PDR 10070

**RE: Operational Works Application for a 6 lot subdivision adjacent to Vixies Road and Snapper Island Drive Wonga Beach – Request for information – OP 4332/2011**

10070  
 CH. 240 SNAPPER ISL. RD.

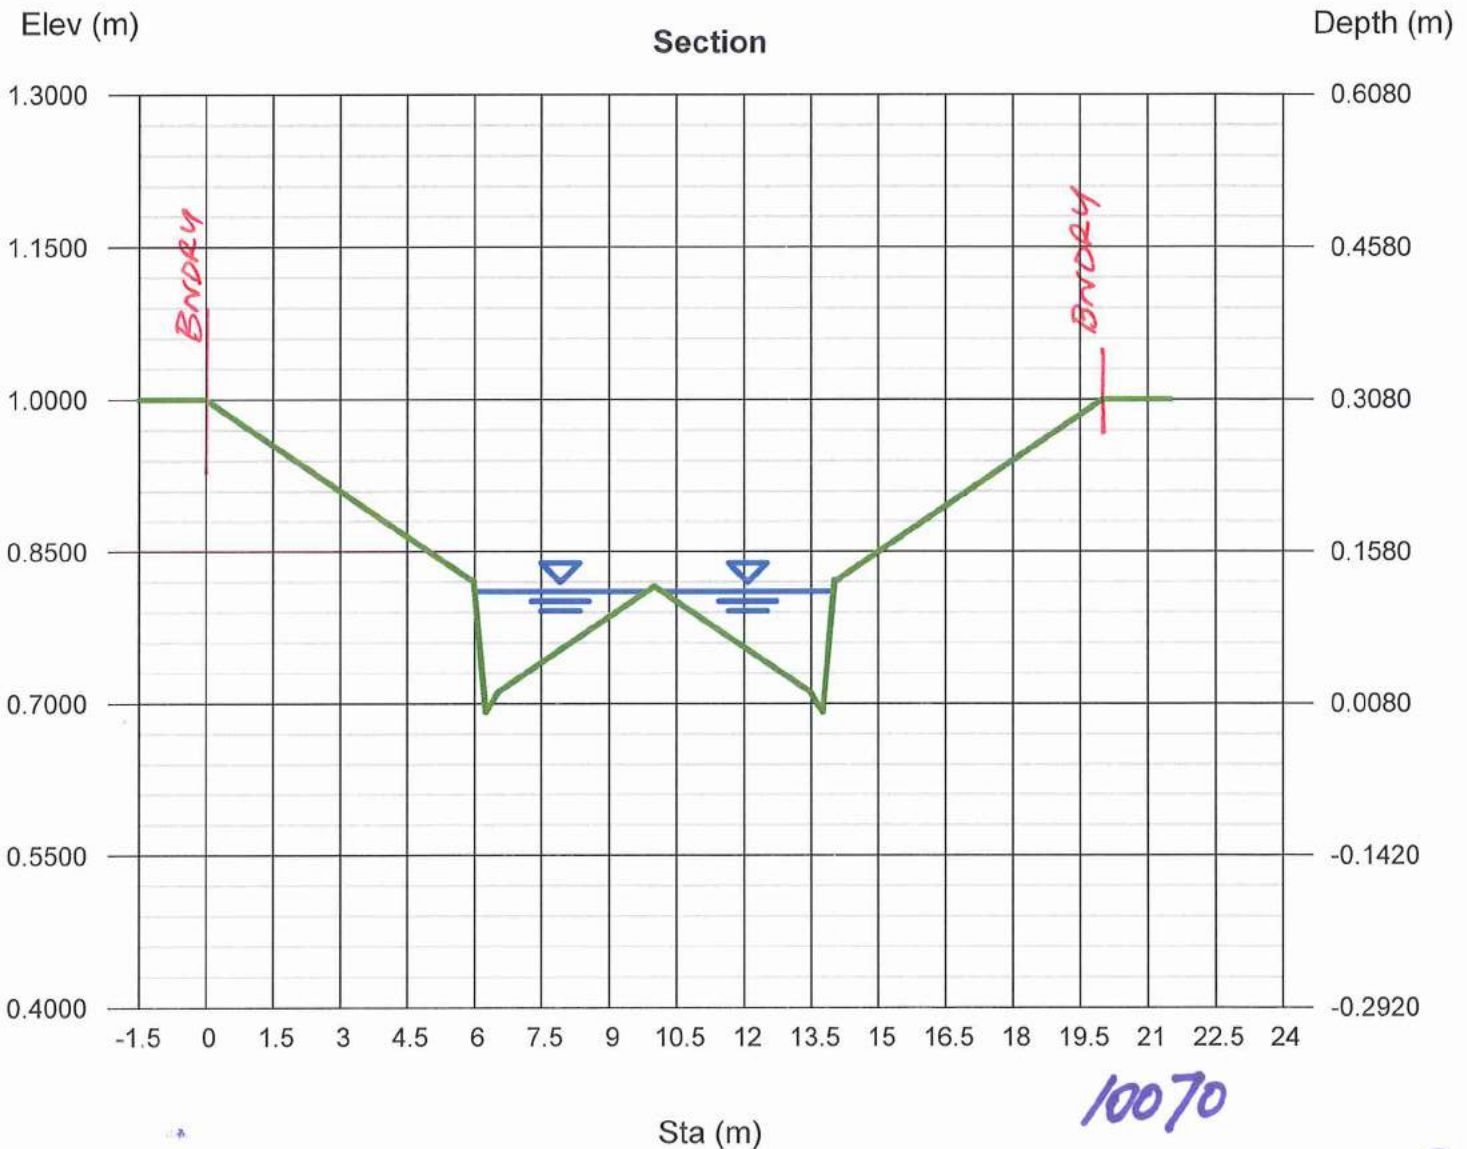
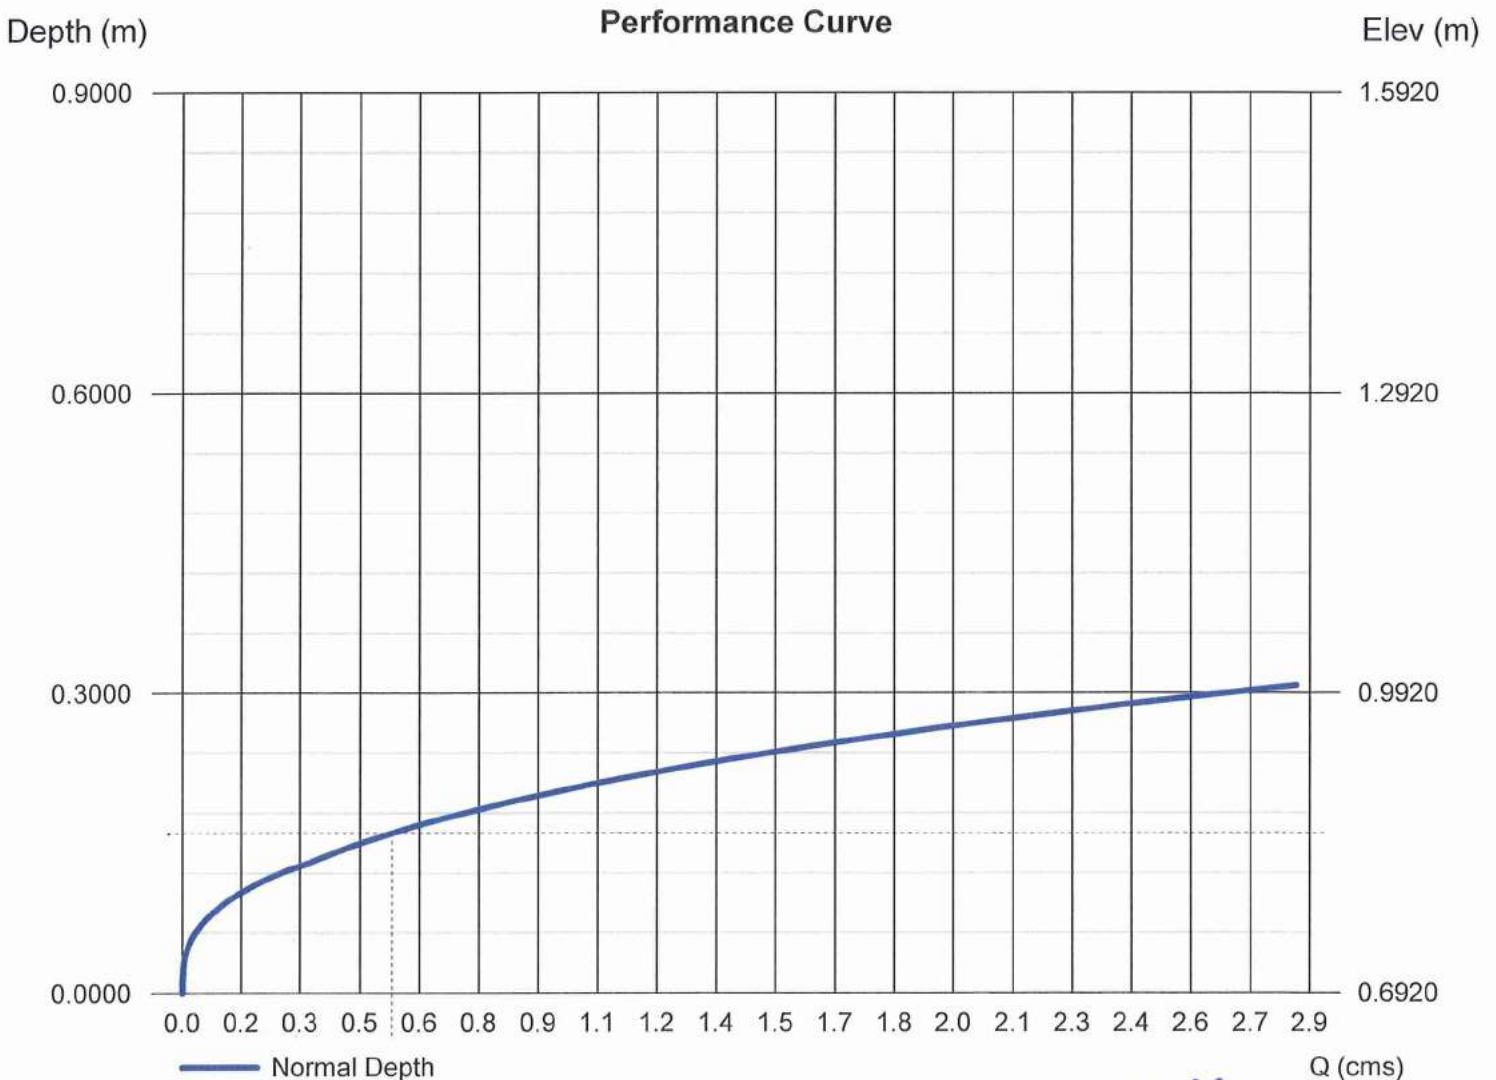
We confirm that the flows produced for the 100 year ARI event is contained within the road reserve and attach diagrams and calculation sheets demonstrating that for the two roads the Q100 flows do not encroach onto the verges.

SCALE	AS SHOWN	DRAWN	AKC
DATE	APRIL 2011	DESIGNED	AKC/AMP
APPROVED		CHECKED	AMP
DWG NUMBER	<b>10070-W01</b>		REV. <b>A</b>

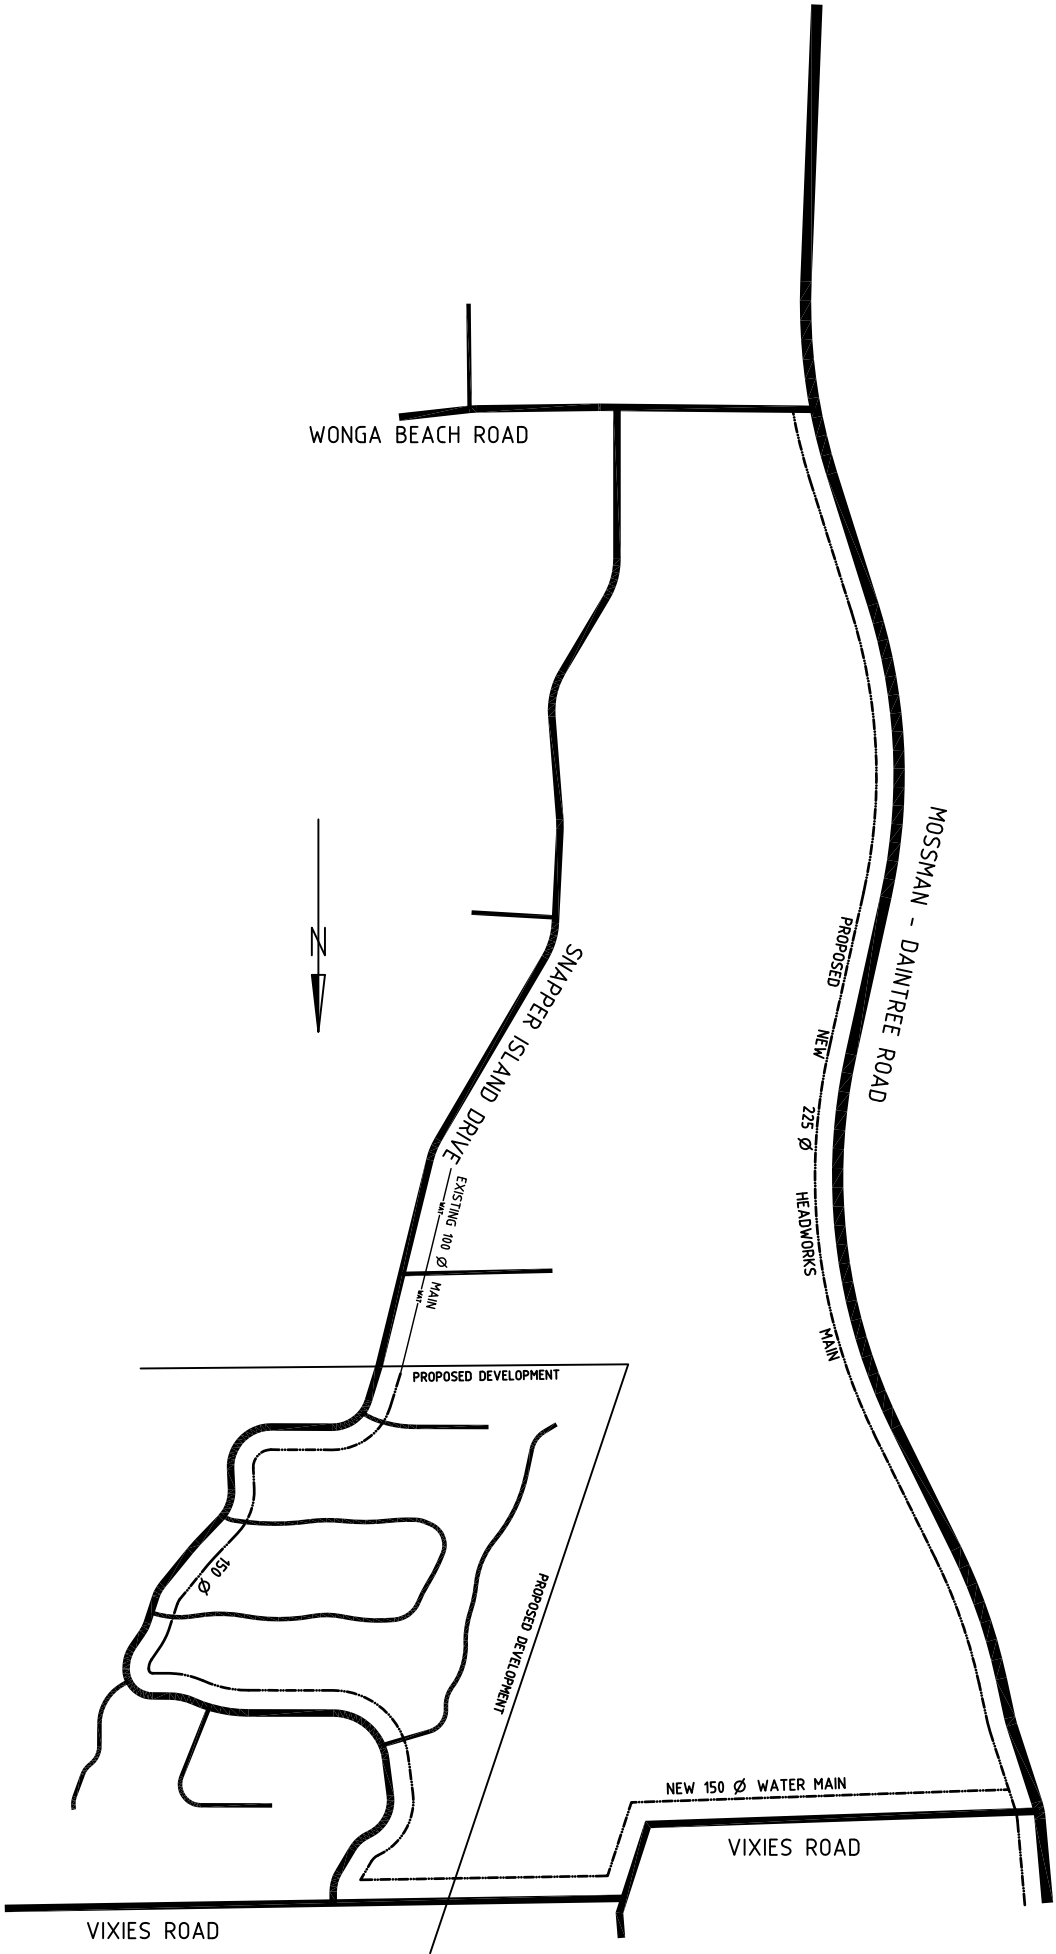
As outlined earlier the overall water supply master plan is not required to be completed at this stage. The provision of water reticulation is in accordance with the previously agreed reticulation plan and a copy of our drawing 10070 – W01 is attached. This plan outlines the agreed reticulation and the design for stage 1 is in accordance with this plan. In relation to condition 16 it is our understanding that this is not required until the 21<sup>st</sup> allotment is applied for.
